Commission of Fine Arts

Revised Concept Presentation

UEPH Barracks

Joint Base Myer – Henderson Hall

REVISED SUBMISSION

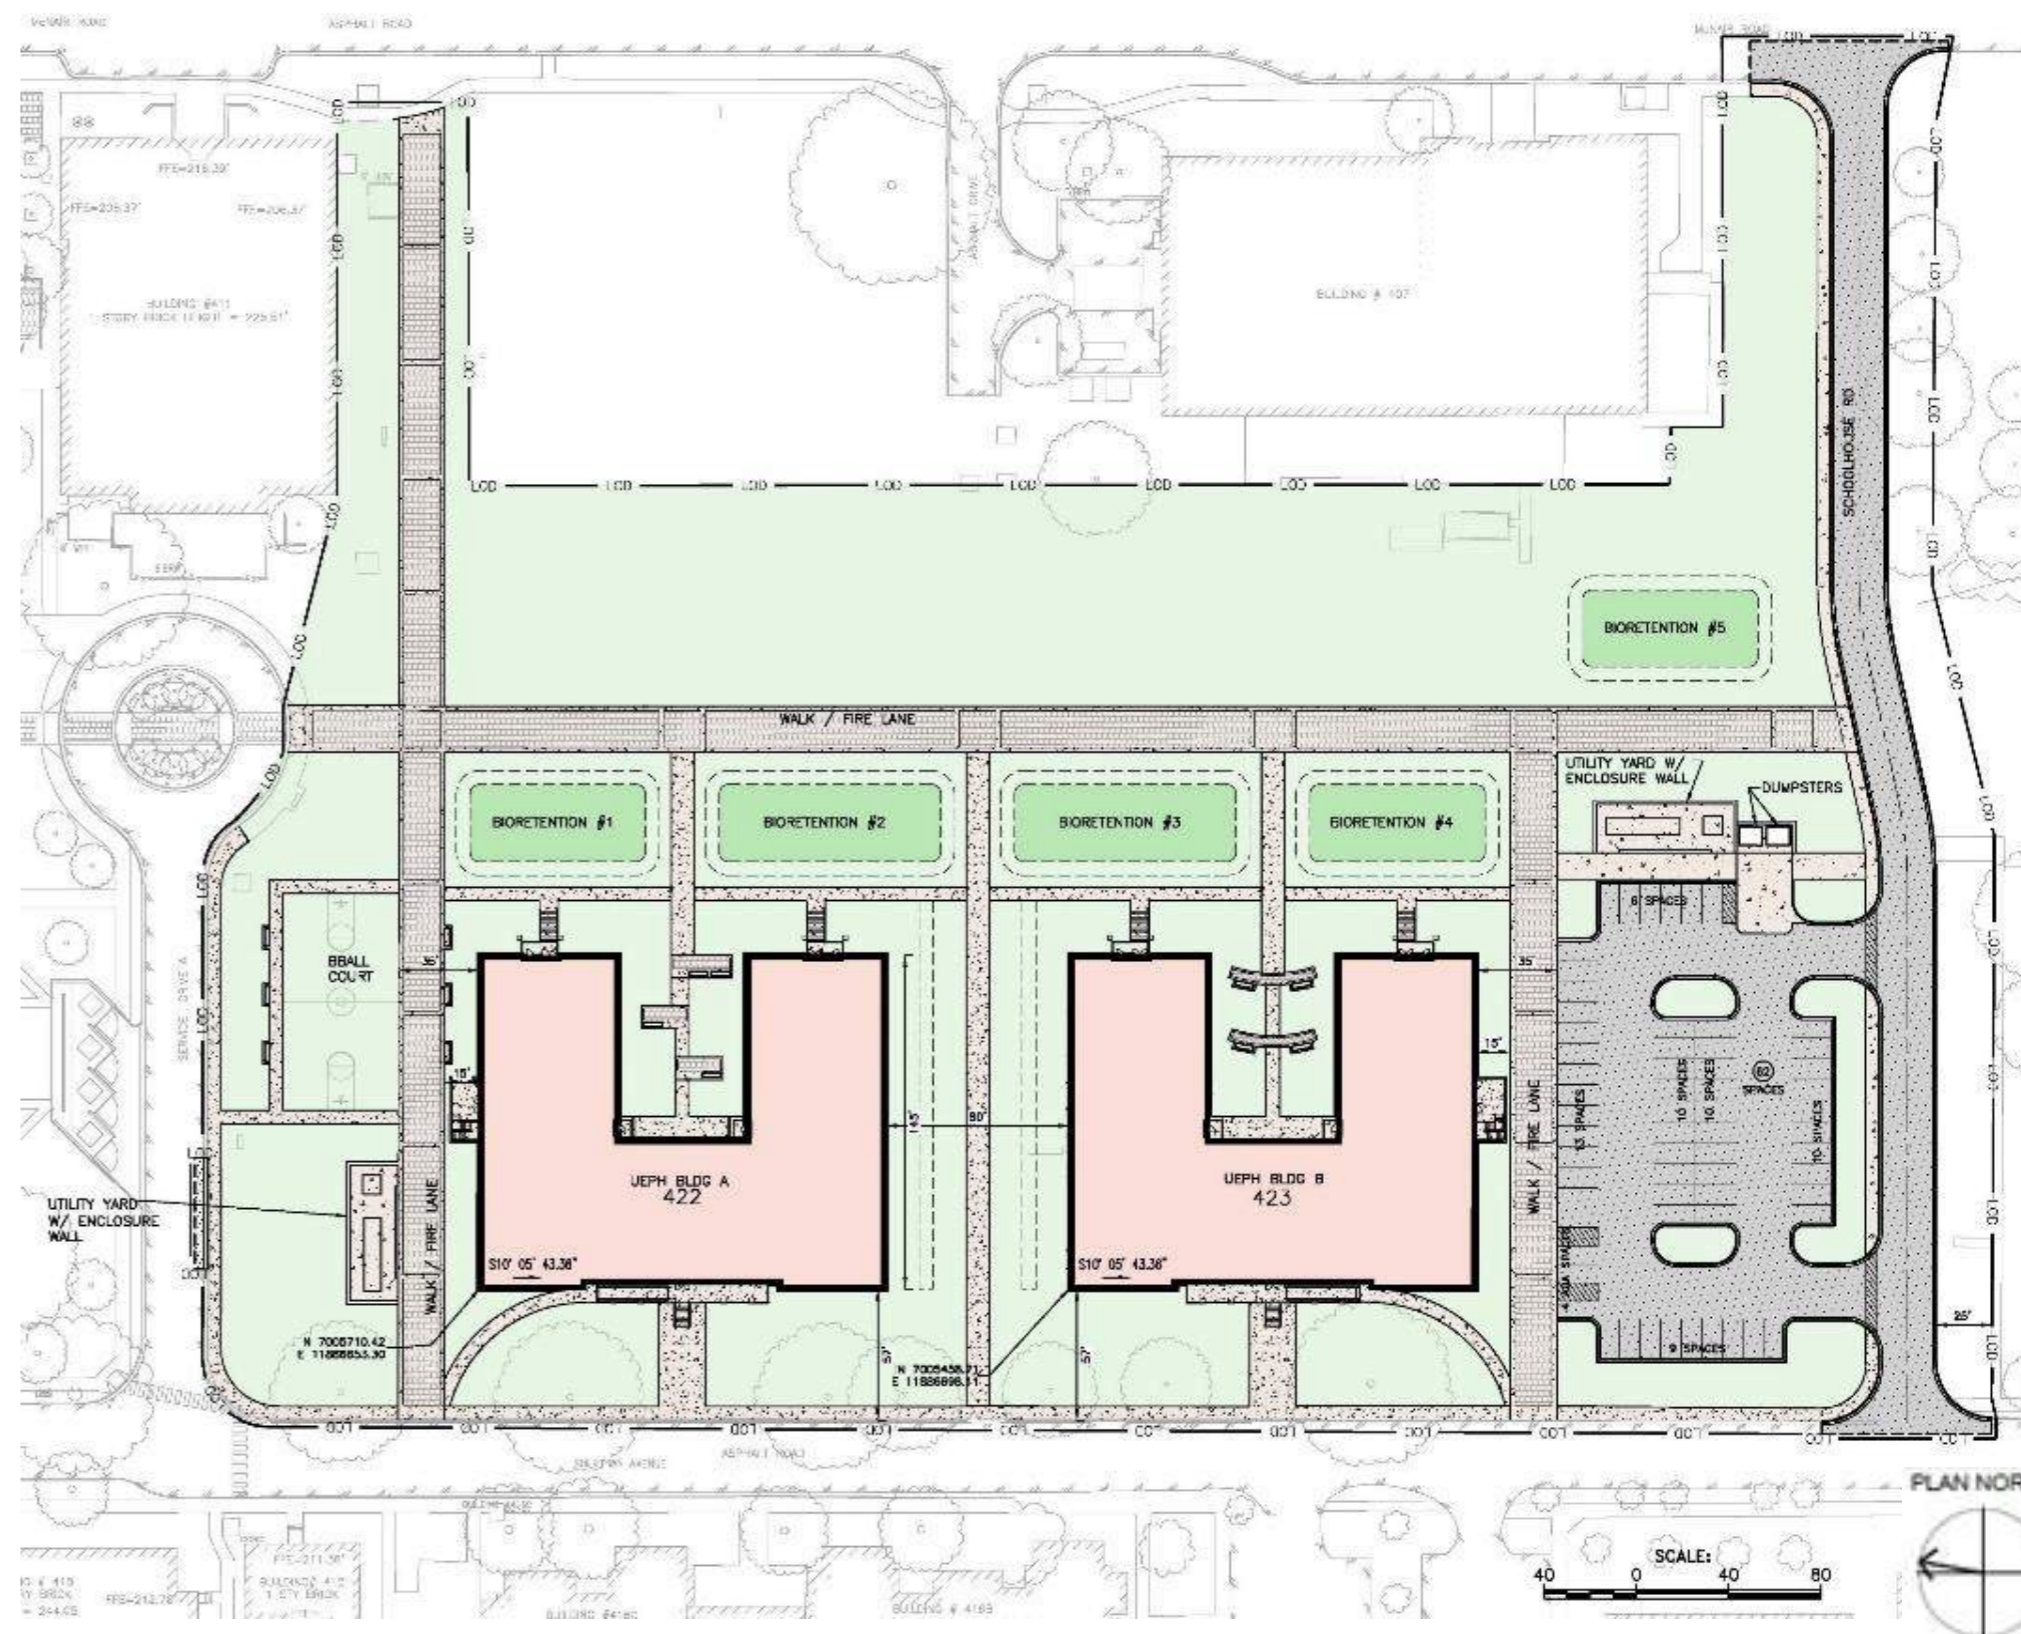
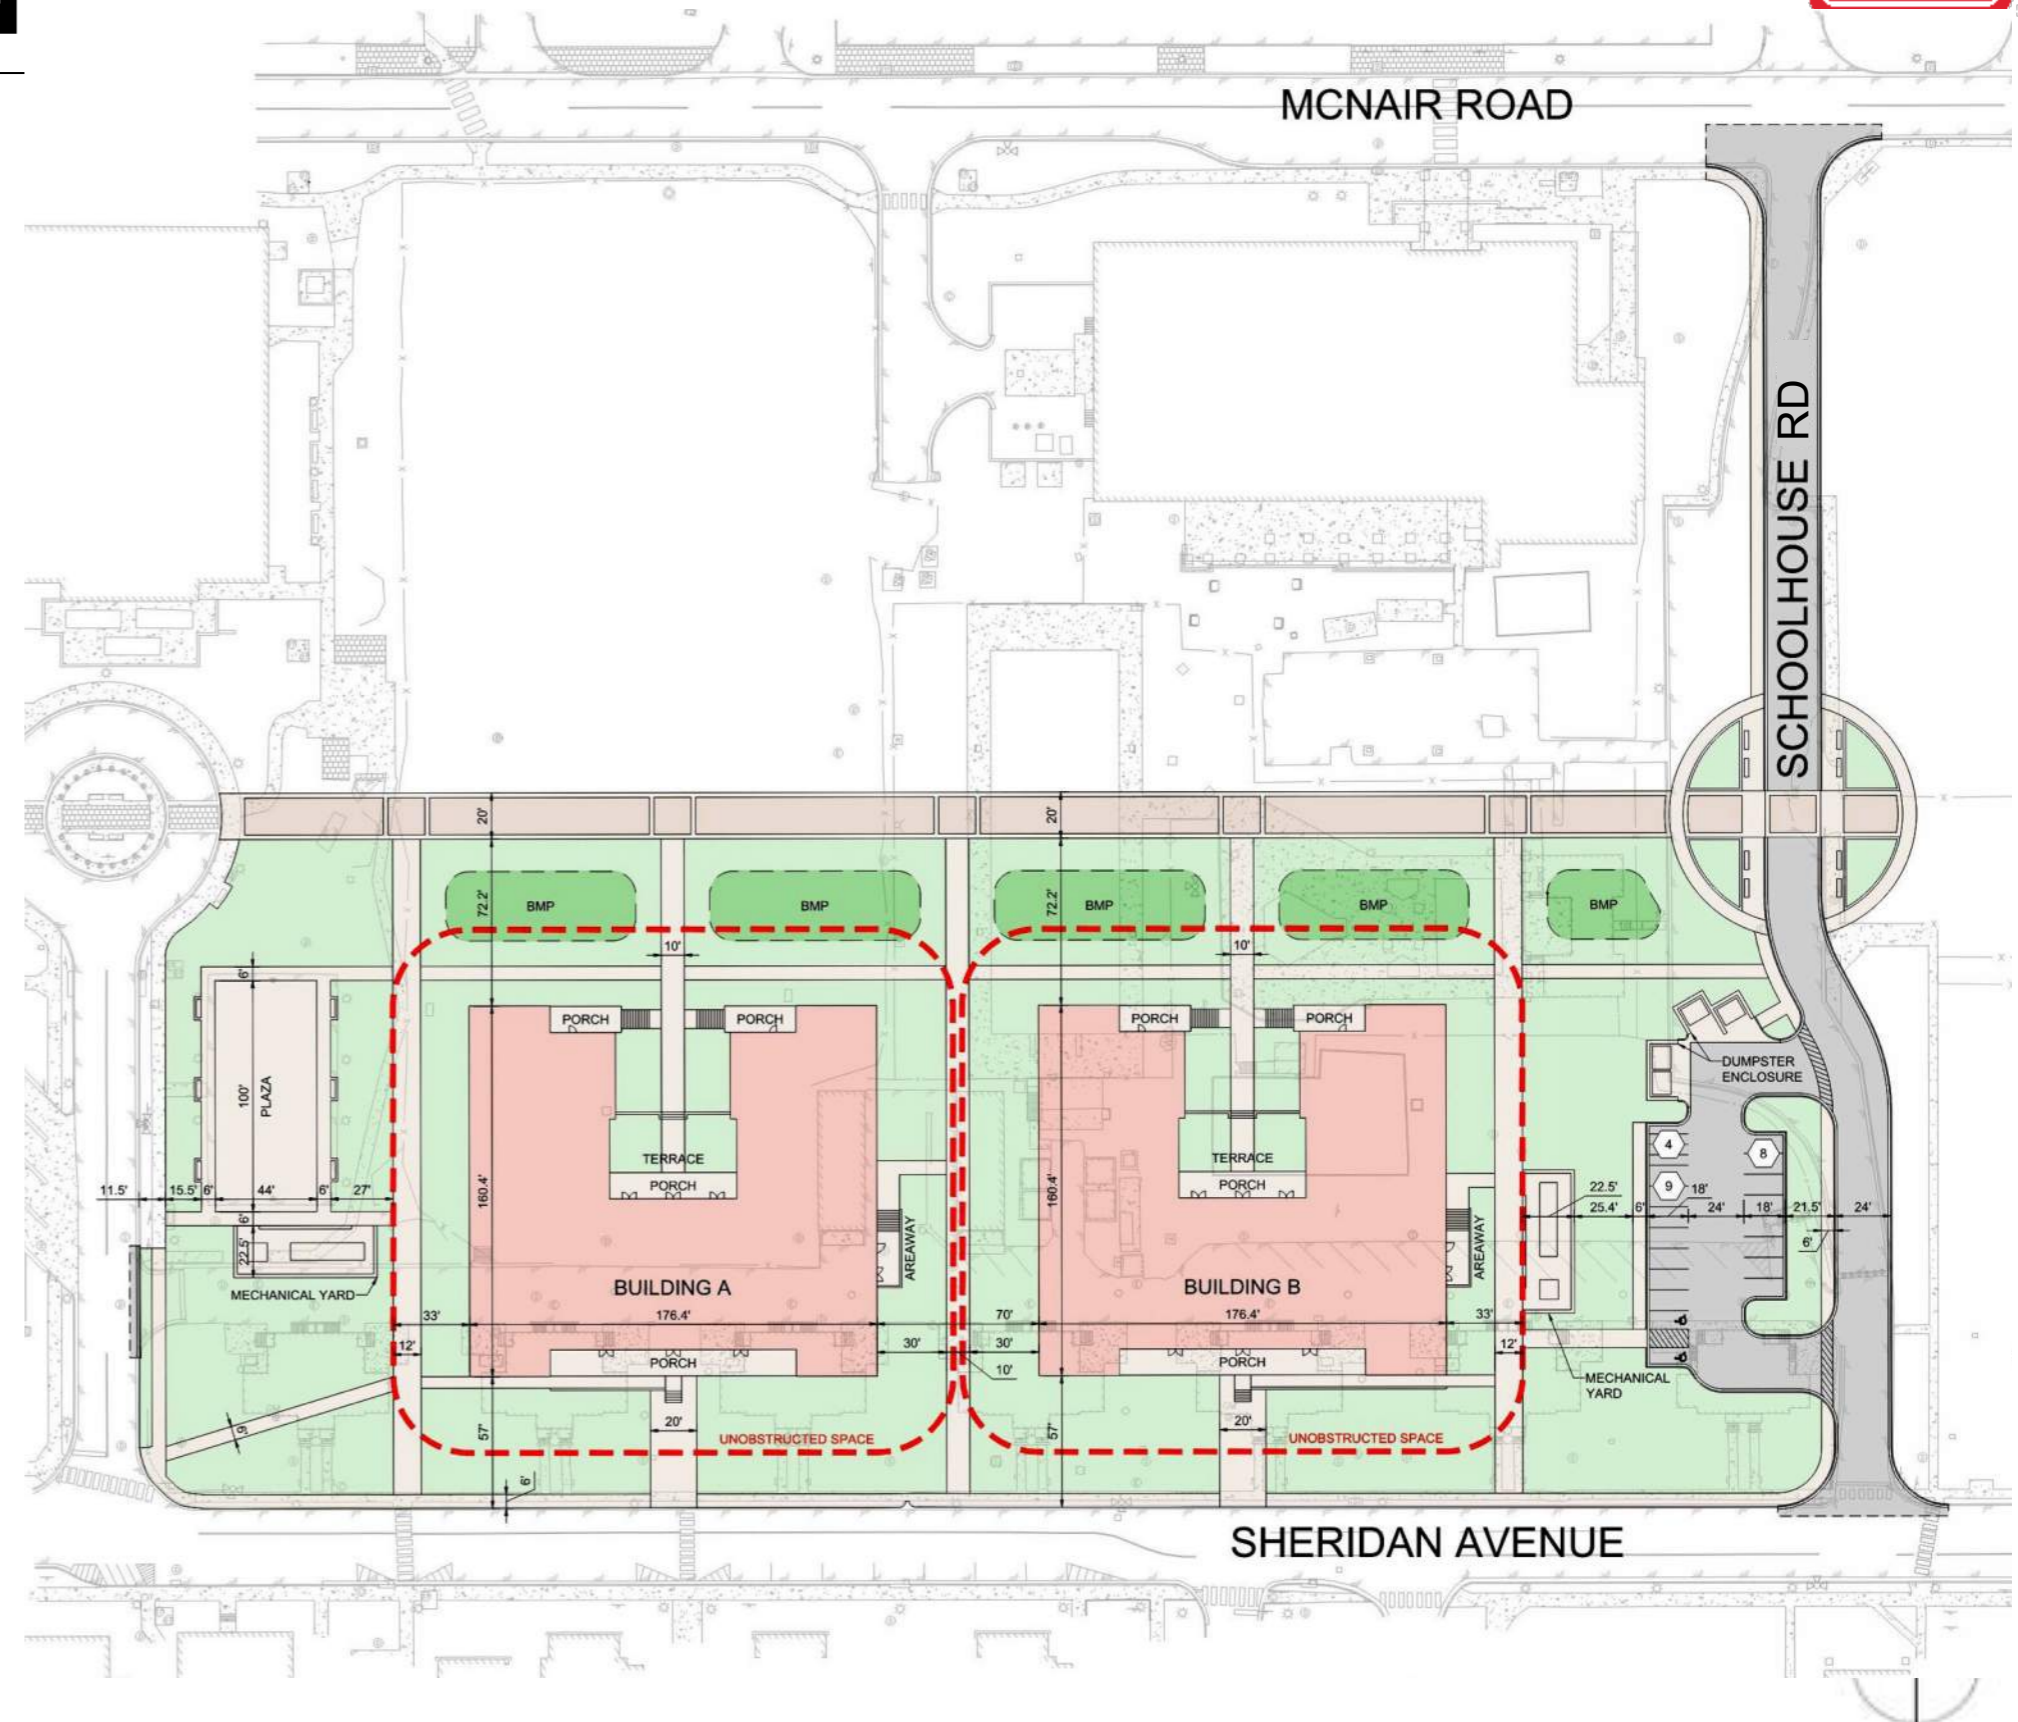
Revised Building Siting

The two new Barracks buildings are still proposed to align with the front façades of existing Barracks Buildings 419 and 421 along Sheridan Avenue. However, they have been relocated approximately 20 ft and 10ft to south to retain additional heritage trees along Sheridan Avenue.

Revised Parking

The parking has been reduced from 62 to 21 spaces and moved set farther back from Sheridan Avenue to preserve the landscape view shed. The 21 spaces includes two accessible spaces and four motorcycle spaces.

Schoolhouse Road will not be realigned but will be resurfaced in its present position to allow preservation of the existing heritage tree on the corner of Schoolhouse and Sheridan.

REVISED LANDSCAPE PLAN

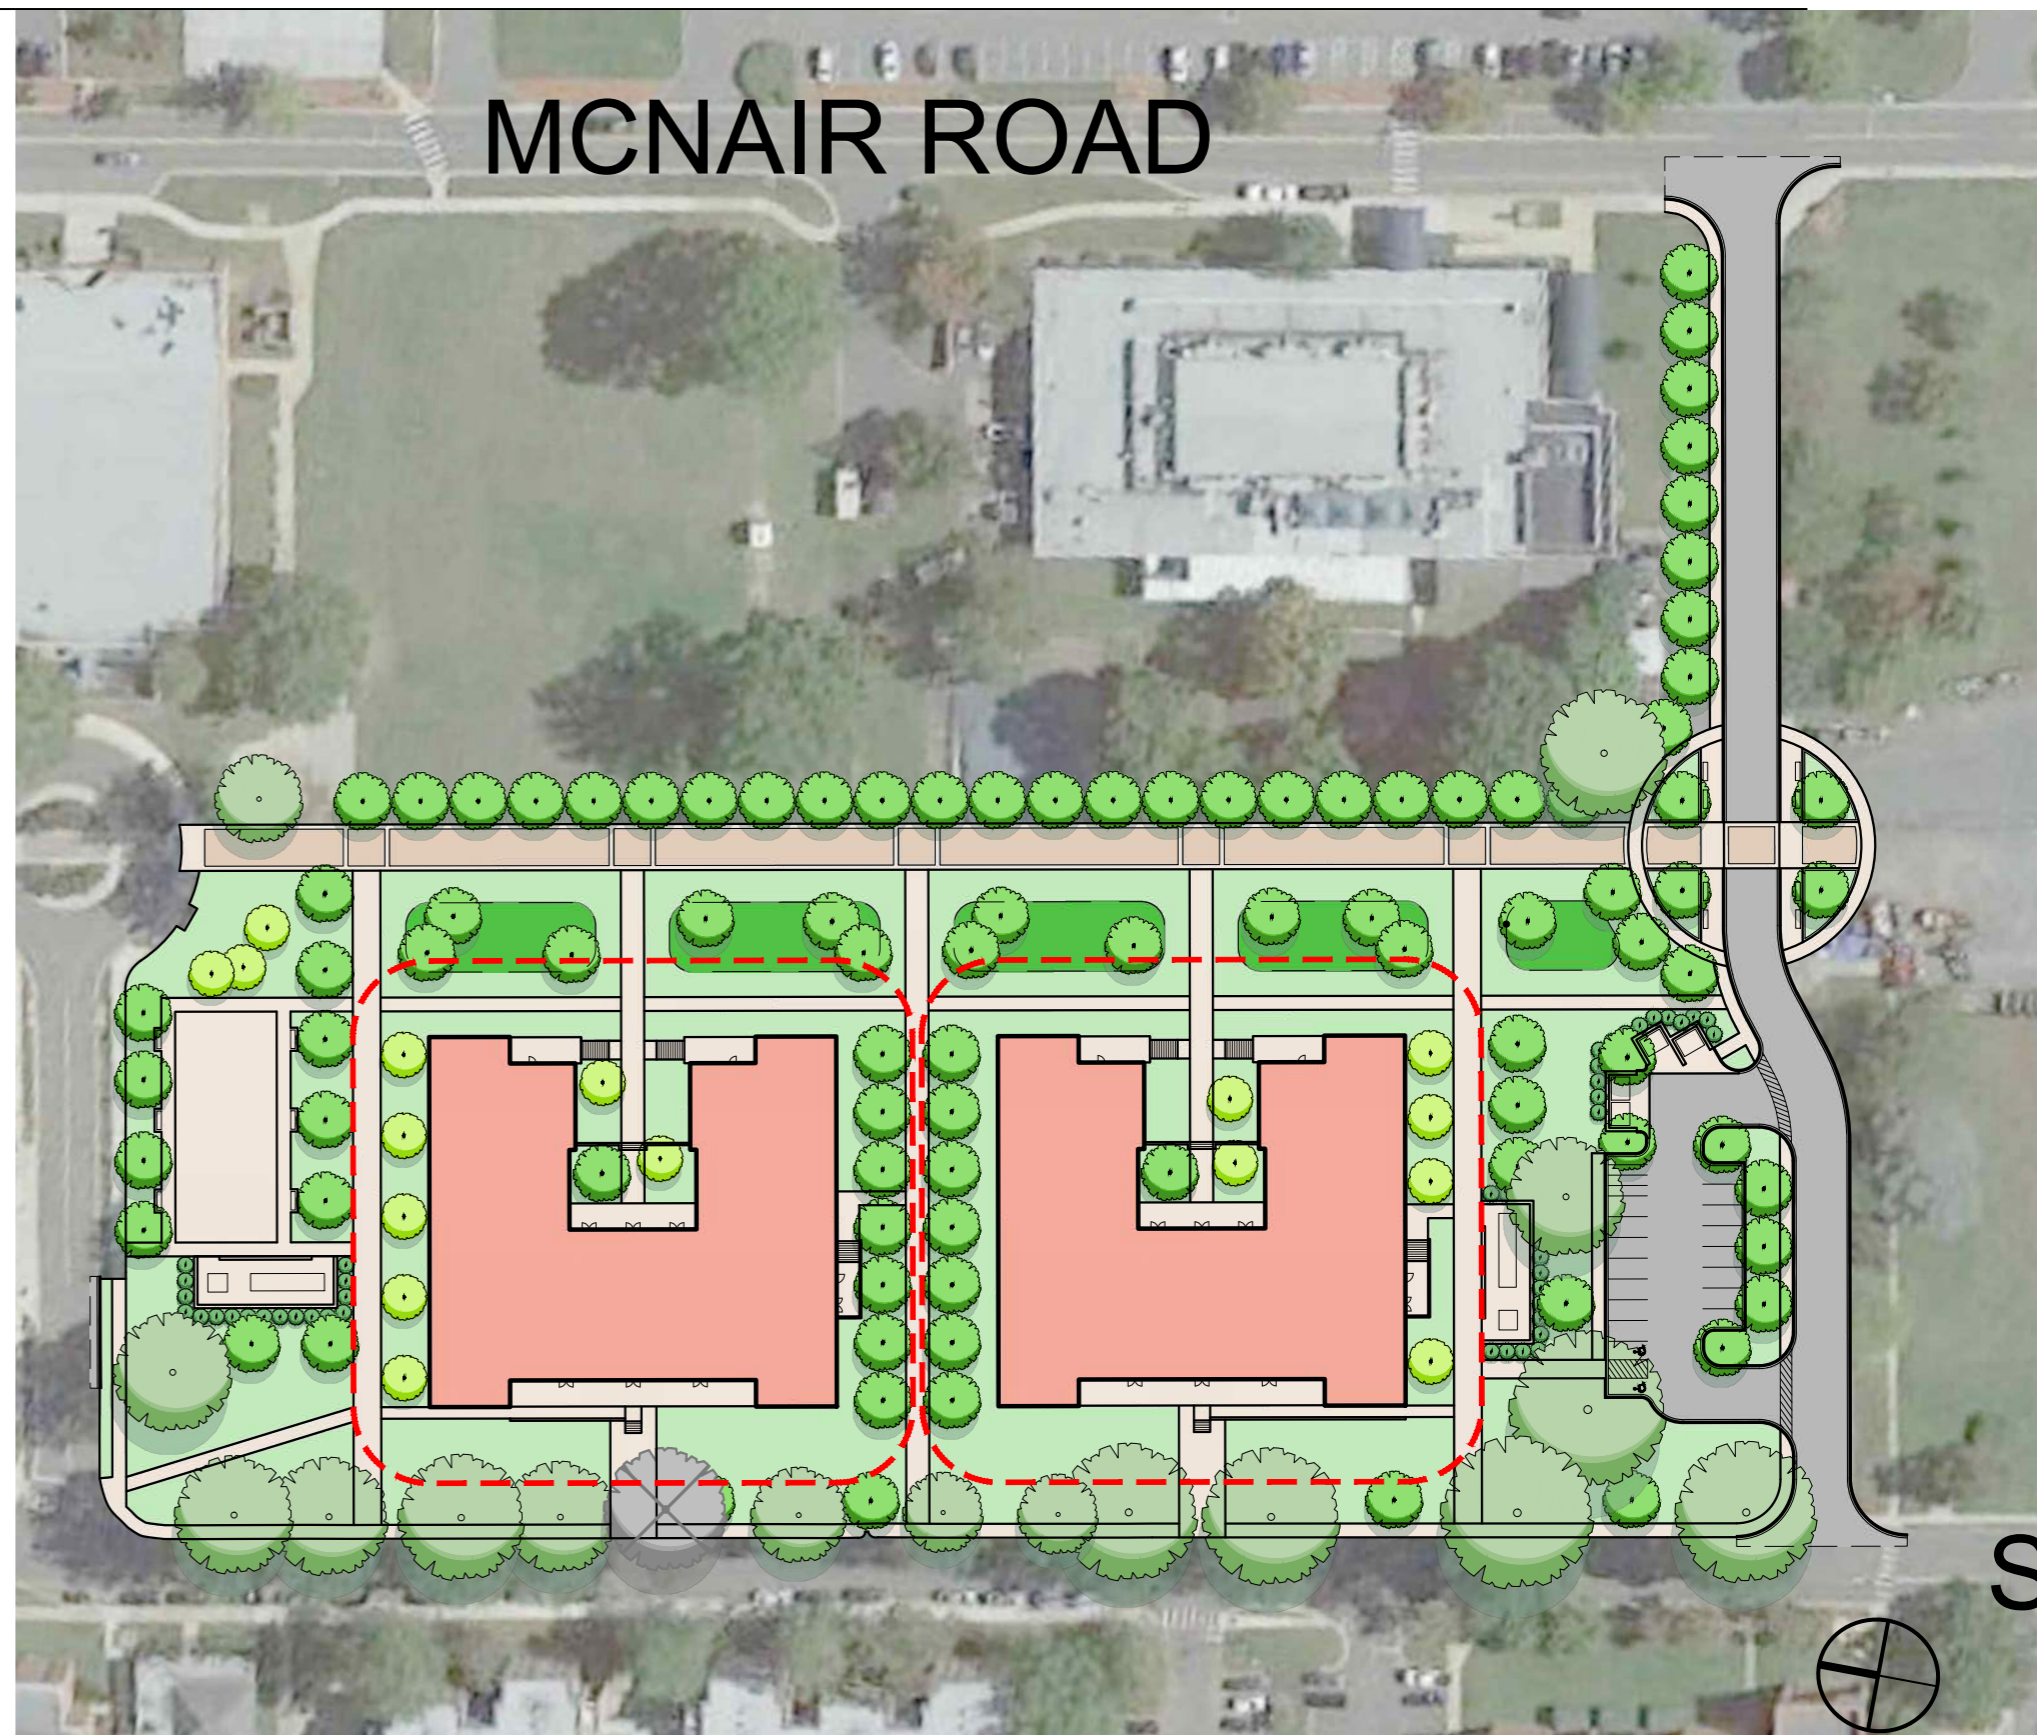
The revised design maximizes the preservation of the street trees along Sheridan Avenue to maintain the existing character of the street frontage landscape. Only a single existing basswood identified to be in very poor condition is proposed to be removed along the street frontage as part of this development.

A total of 88 trees will be removed within the limits of disturbance of the proposed Unaccompanied Enlisted Personnel Housing development; this total includes the decaying basswood street tree, invasive species, two overgrown evergreen hedges, and other trees in various conditions. The scope of the project necessitates the removal of 13 specimen trees (trees having a Diameter at Breast Height of 24" or greater, as outlined in the Unified Facilities Criteria on Landscape Architecture), which are in "fair" condition or better. To mitigate for the loss of the tree canopy coverage on the project site, over 90 large canopy trees are proposed in and around the barracks landscape. The National Capital Planning Commission's "*Tree Preservation and Replacement Resource Guide*" will be utilized to calculate the total tree replacement required for the project, but the design proposes an onsite rate greater than the Guide's 6:1 replacement for trees with a DBH of 25" or greater. An offsite Habitat Restoration Area has been selected to fulfill the remaining balance of required replacement trees.
